Product Recall: OPV Spring

The highest priorities of Halcyon Manufacturing are the quality of our products and the safety of our customers. I am writing to you to provide details regarding the voluntary recall of select Overpressure Relief Valve (OPV) Springs.

Halcyon Manufacturing Inc. in cooperation with the US Consumer Product Safety Commission has initiated a voluntary recall of select Eclipse, Evolve, Explorer, Pioneer and CCR35 buoyancy compensators (BCDs) manufactured between January, 2006 and September, 2008. In addition, select Halcyon inflatable devices (Lift Bags, SMB's, DAM's, Surf Shuttles and Diver Lift rafts) may also be affected.

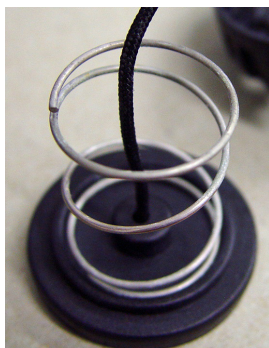
The following steps will assist the customer in identifying the serial number on their Eclipse, Evolve, Explorer, Pioneer or CCR35 buoyancy compensators (BCDs) manufactured between January, 2006 and September, 2008. If you cannot locate a serial number on your BCD please contact us.

If the serial number begins with the following sequence, the OPV spring in the BCD should be inspected:

61, 62, 63, 64, 65, 66, 67, 68, 69, 6A, 6B, 6C, 71, 72, 73, 74, 75, 76, 77, 78, 79, 7A, 7B, 7C, 81, 82, 83, 84, 85, 86, 87, 88, 89

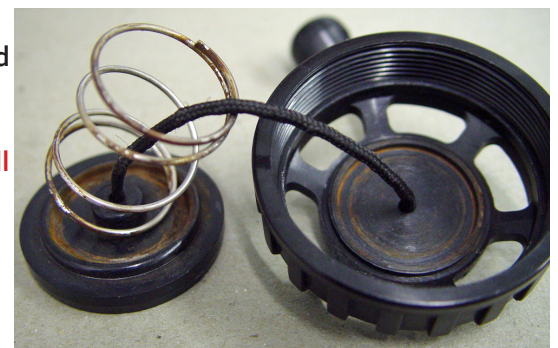
A non defective OPV spring will look like these. Some discoloration is common. Spring should remain strong, and appear 'normal' when dirt or coloration is removed.

A defective OPV spring will look like this. Note excessive corrosion in the OPV assembly. When scraped off the spring exhibits possible pitting and damage.

3. If defective, the spring should be removed and replaced. The new spring should be obtained from a Halcyon Authorized facility and threaded into the pull dump cord.
